Engineering Evaluation of Bollard Fence

Rio Grande, Hidalgo County, Texas

United States of America v. Fisher Sand and Gravel Company, Civil Action No. 7:19-CV-403

August 2021

Figure 1: Construction Details from Plans by TGR Dated October 30, 2019

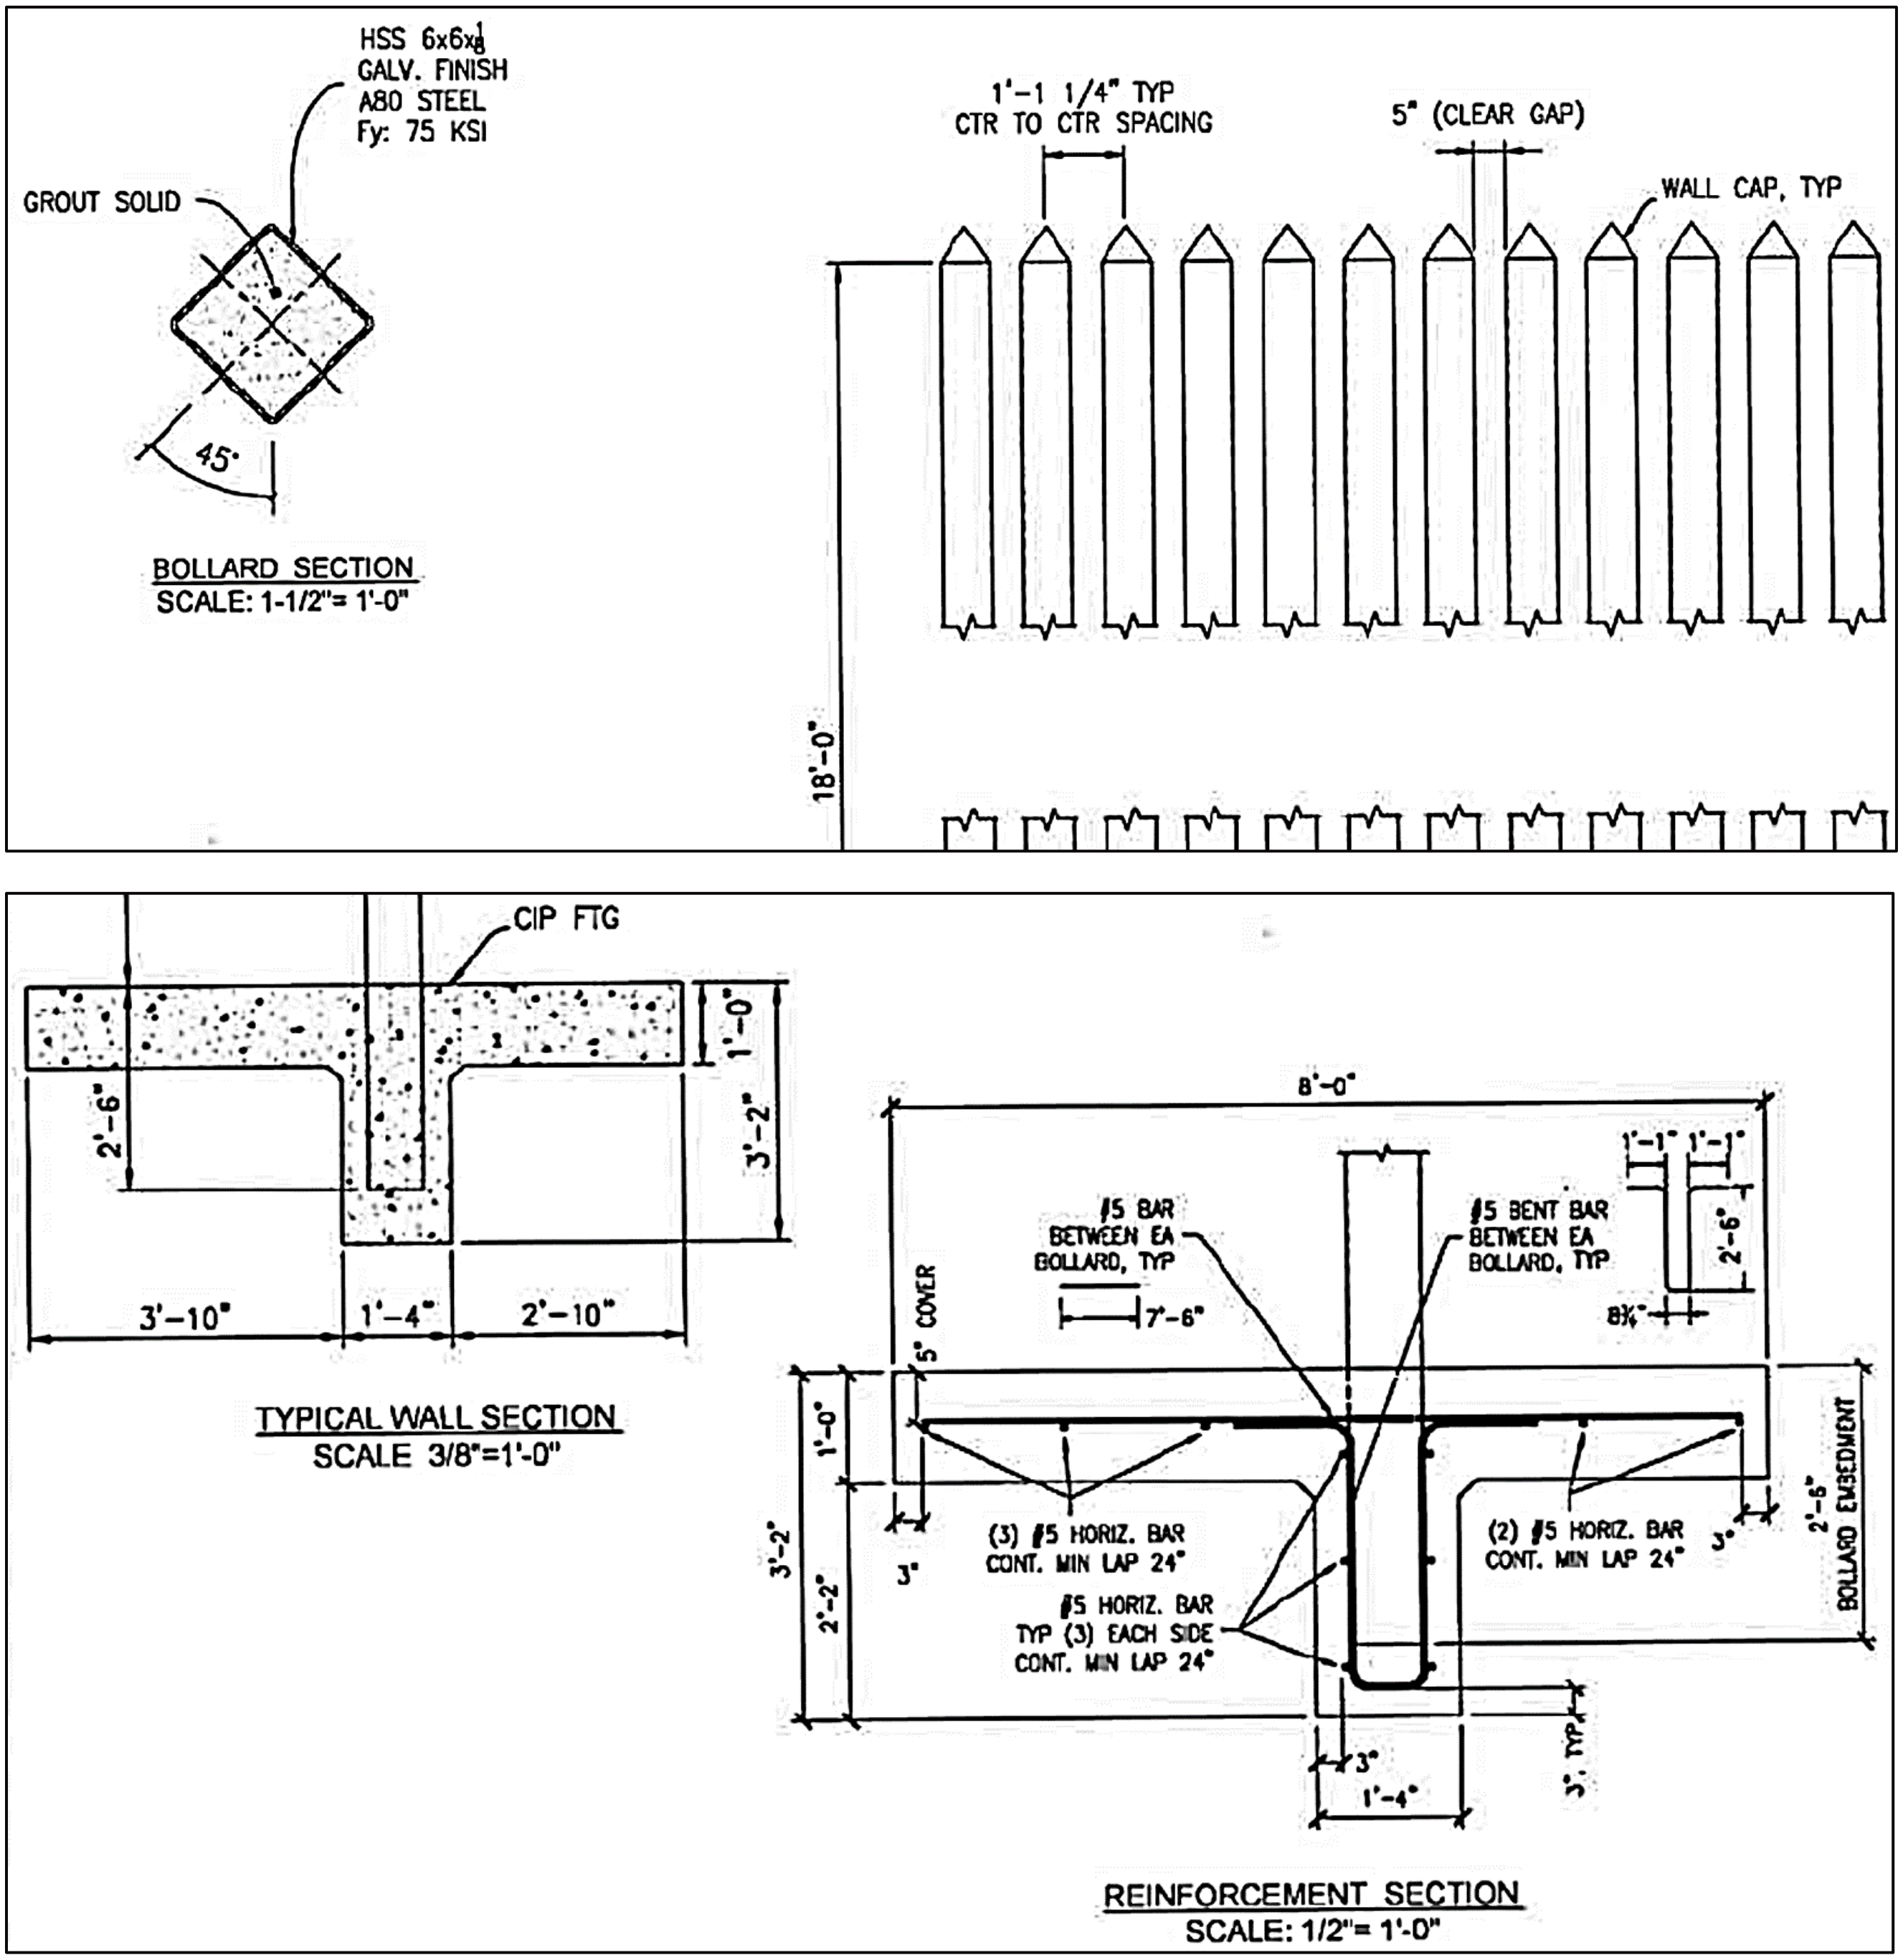
Mr. Fisher reported that the fence was constructed as shown on the plans provided (details shown on Figure 1). An exception is that the bollards were not grouted solid as shown on the plans, and instead were backfilled with an unspecified grade "pea" gravel. No material specifications, quality control test results, or field reports were provided regarding the backfill of the bollards and no field verification was completed for this investigation. Pre-cast concrete caps were grouted to the top of the fence bollards using a rebar dowel. Shop tags providing records of galvanizing and photographs of example materials are shown on Figure 3.

The depth of the concrete footing shown in the design (Figure 1) is 1 foot up to the steel bollards, where the depth increases to 3 feet for the embedment of the bollards. The edge of the footing on the riverside of the fence was evaluated at five locations along the alignment to confirm the depth of the concrete. This evaluation indicated that the edge of the concrete is not a uniform depth of 1 foot, with one location measuring as little as 4.5 inches as shown on Figure 14. One location evaluated near STA 156+00 did measure a full 12 inches as shown on Figure 15.

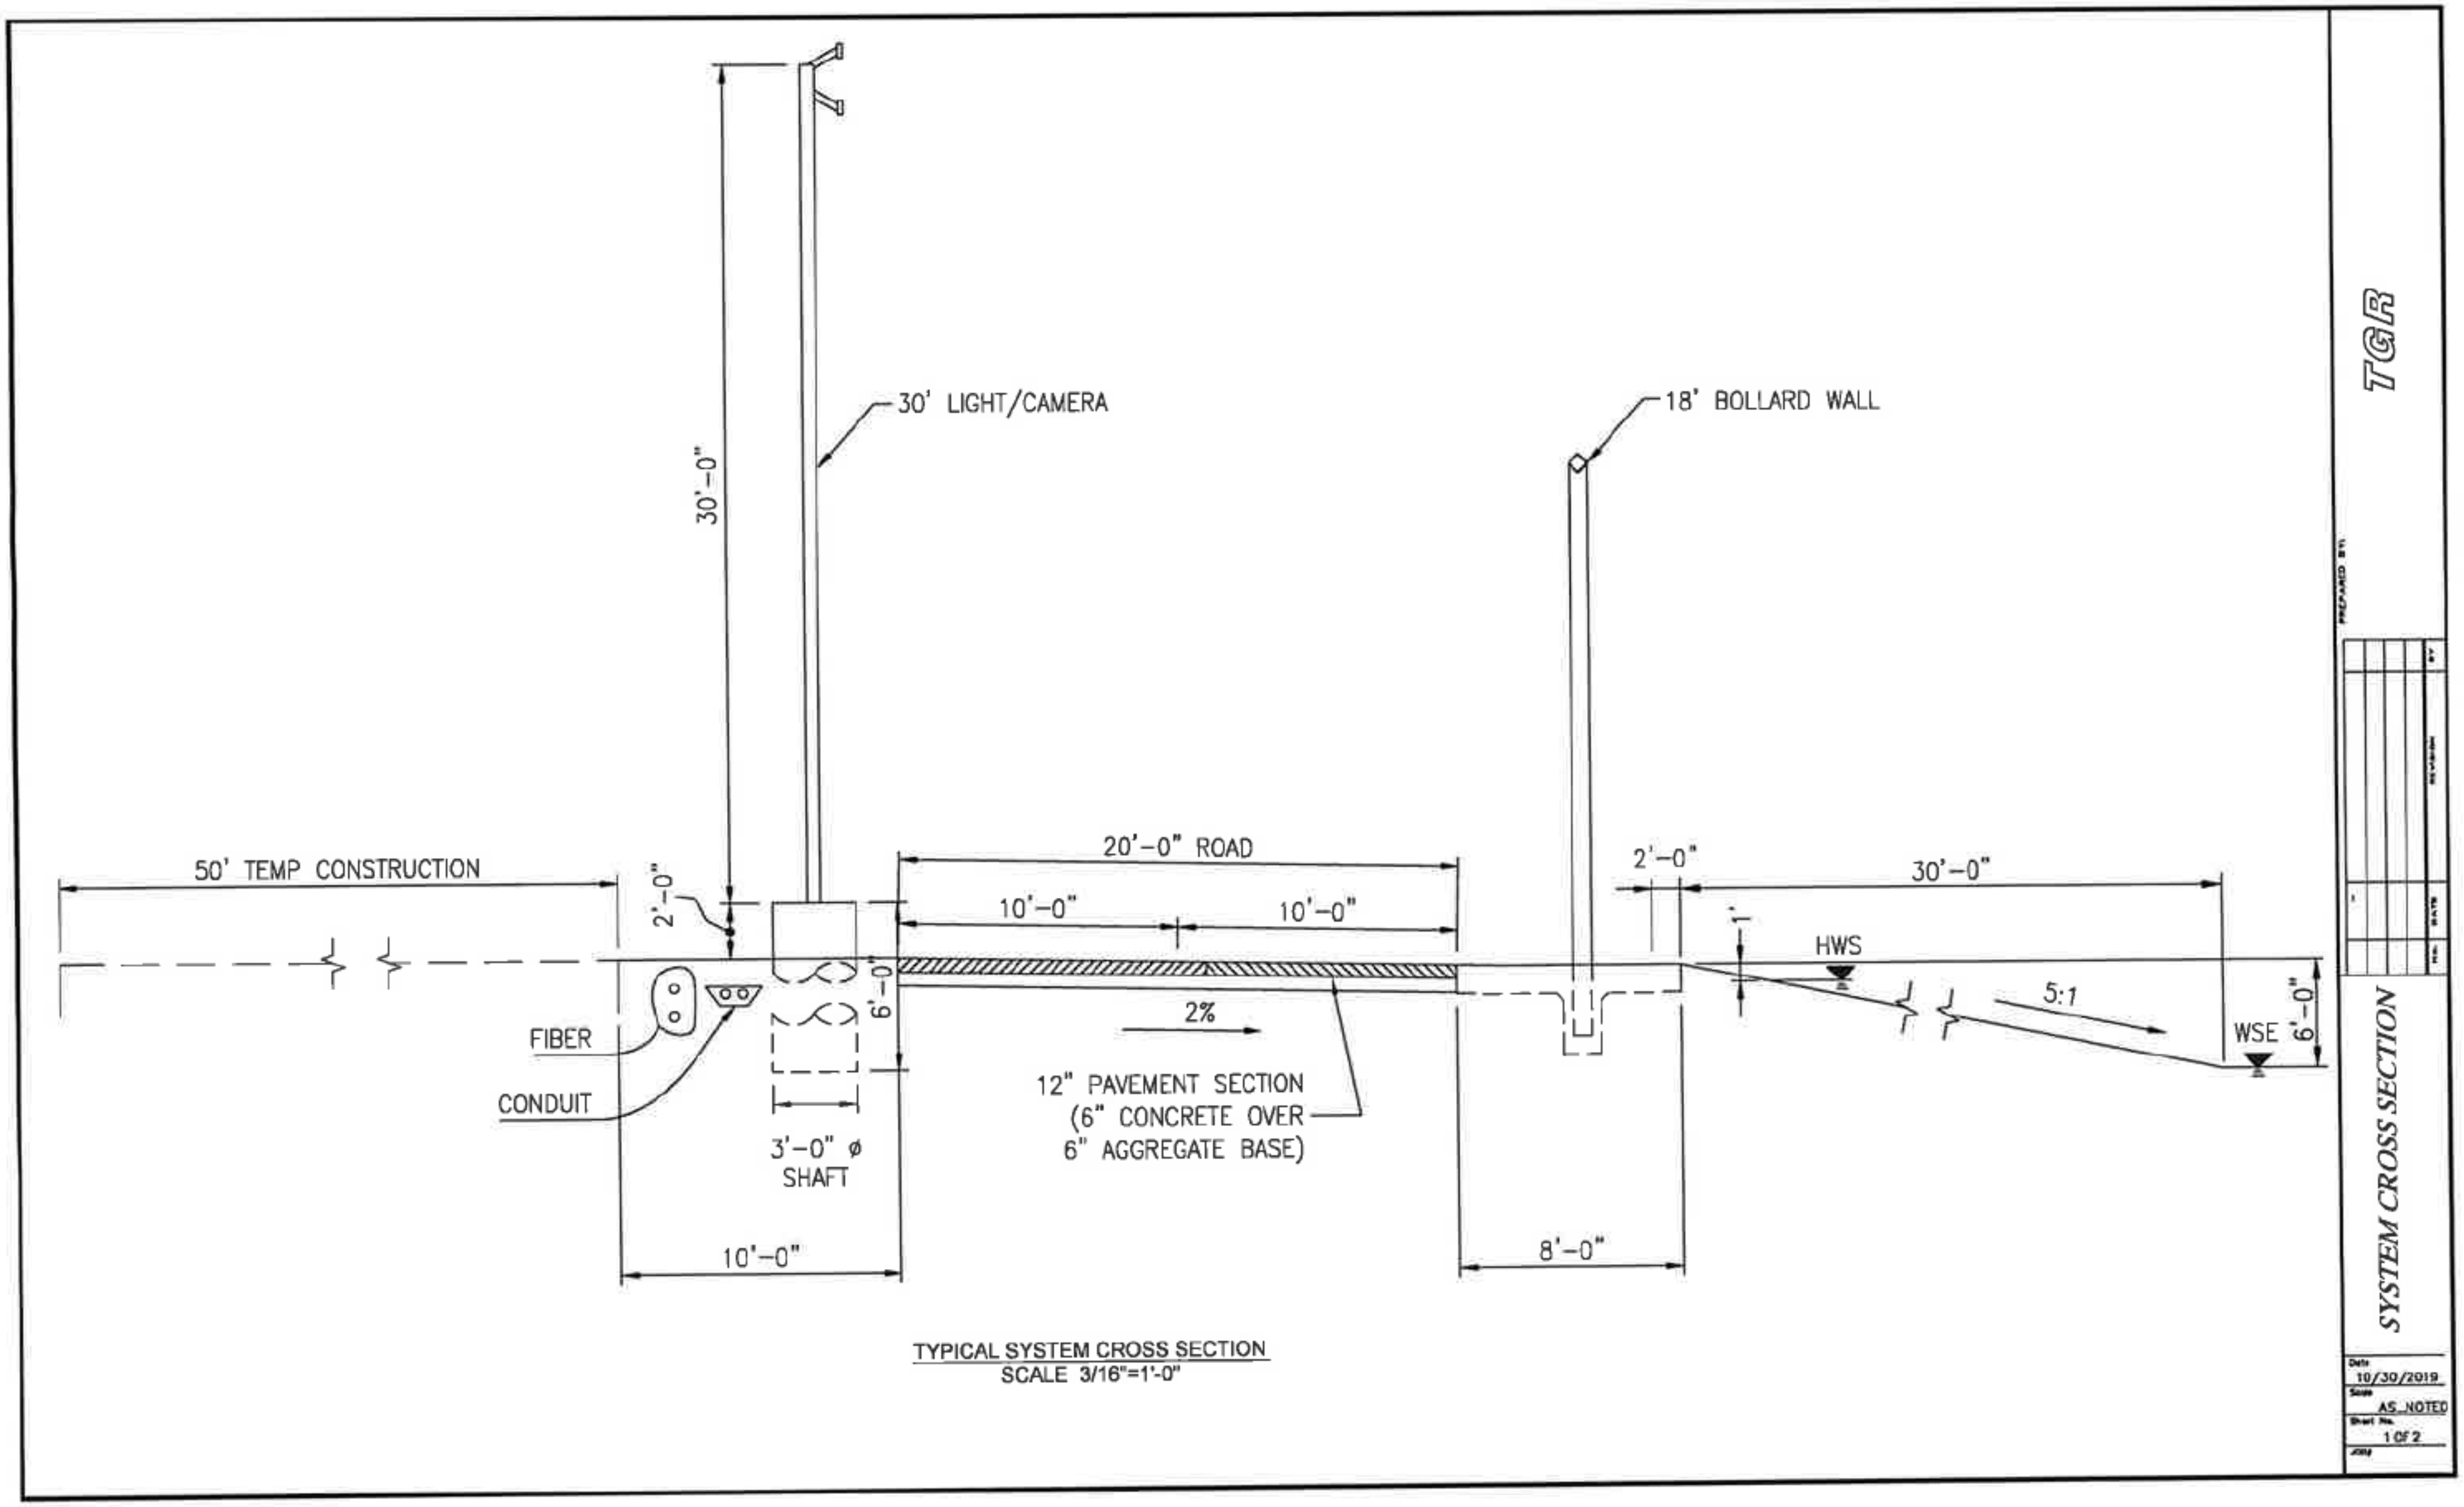
The typical system cross section depicts the 3-foot-diameter 6-foot-long precast shaft protruding 2 feet above grade, as shown in Figure 6.1. The fence bollards are 1 foot and 1¼ inch on centers and have a clear space of 5 inches along the centerline of the fence, as shown in Figure 6.2.

A light/camera monopole founded in a precast concrete shaft foundation is shown in Figure 6.8. The light pole foundation is designed as 4 feet embedded into the ground with 2 feet exposed above ground as shown in Figure 6.1; however, the exposed height was at times higher due to variance in the finished grade with respect to the typical system cross section. The light/camera pole is also galvanized steel. No details were provided of the light pole anchor detail into the concrete foundation.
